23 January 2018  
Ref No. 29807ZRlet

**PRELIMINARY GEOTECHNICAL ADVICE ON INTERACTION WITH THE EPPING CHATSWOOD RAIL TUNNEL**  
**THE PROPOSED ARTS PRECINCT, MACQUARIE UNIVERSITY, NSW**

We confirm that JK Geotechnics have prepared two geotechnical reports for the proposed arts precinct at Macquarie University (Ref. 29807ZRpt Rev. 1, dated 6 June 2017 and 29807ZRpt2, dated 8 December 2017). We have been provided with 'Rail Corridor Impact Study – Main Works' drawing (Drawing Numbers APP STR-SK0012 Issue B, dated 20 September 2017) prepared by Taylor Lauder Bersten Pty Ltd (TLB).

SKETCH A

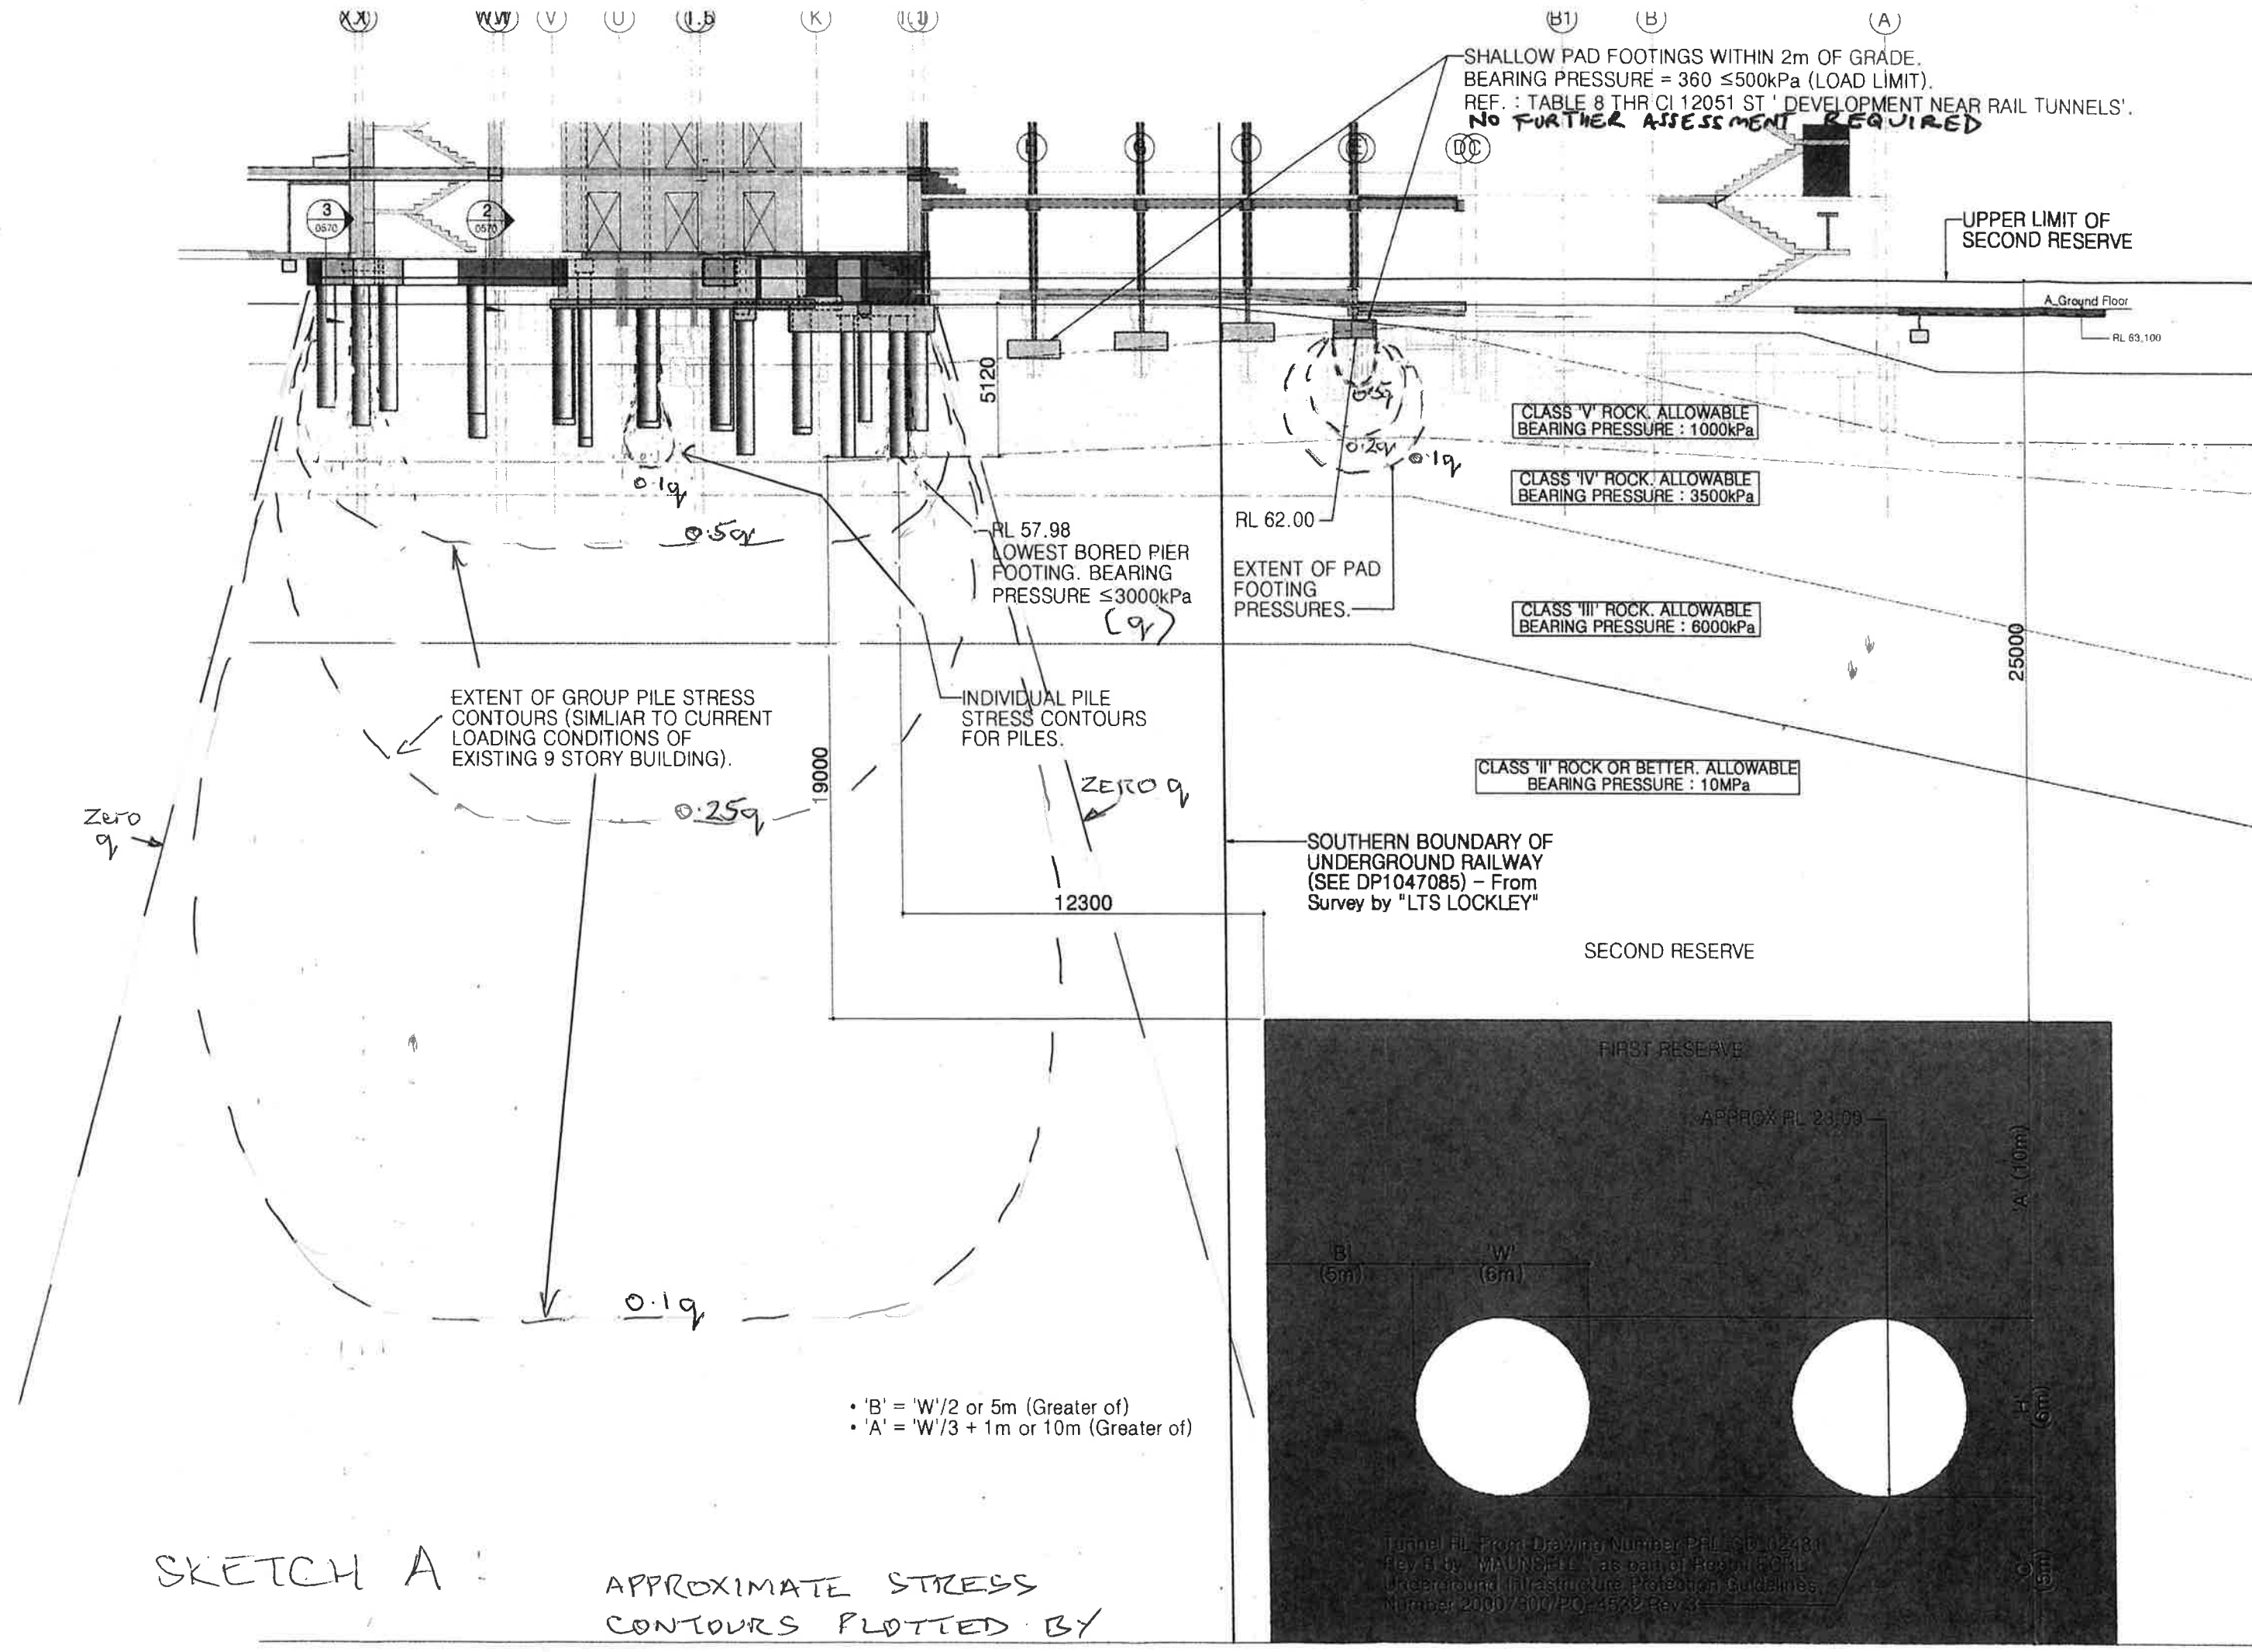
As indicated on the TLB drawing, the upper boundary of the First Reserve will be at approximately RL39m; approximately 19m below the proposed maximum founding depth of the bored pier footings and off-set approximately 12.3m to the south of the First Reserve southern boundary. The TLB drawing also includes approximate pressure bulbs for the individual piles, pad footings and the new nine storey core, based on the attached Sketch A. The pressure bulbs were assessed by the undersigned based on pressure distribution curves (with depth) well established in the geotechnical literature and using the dimensions of the footings and the 19m square plan dimension of the new nine storey building.

Based on our experience of 2D and 3D finite element analyses of buildings constructed over, and adjacent to, road and rail tunnels, and our estimation of the likely pressure distribution, with depth, in our opinion:

- The unloading associated with the demolition of selected sections of the nine storey building and subsequent reloading as the proposed refurbishment is constructed (including new footings and new nine storey central core) will have negligible net impacts at the depth of the tunnel.
- The pressure bulbs below the toes of individual piles and pad footings will be relatively localised and minimal bearing pressure will be imposed at a depth equivalent to 2B (where B is the pile diameter, in metres) and 3B (where B is the footing width, in metres).

- 
- The proposed depth of the new piles will be similar to the existing piles. The current pressure distribution associated with the pile group is expected to essentially remain unchanged. We assume that as part of the design of the tunnel, the impact of the existing buildings on the tunnel was assessed and the tunnel designed accordingly.

On the basis of the above, we consider that there will be negligible additional loads/bearing pressures impacting the First Reserve, or the tunnel, associated with proposed footings.

In conclusion, it is our opinion that the development will have no negative impact on the rail corridor or the integrity of the infrastructure through its loading and ground deformation.
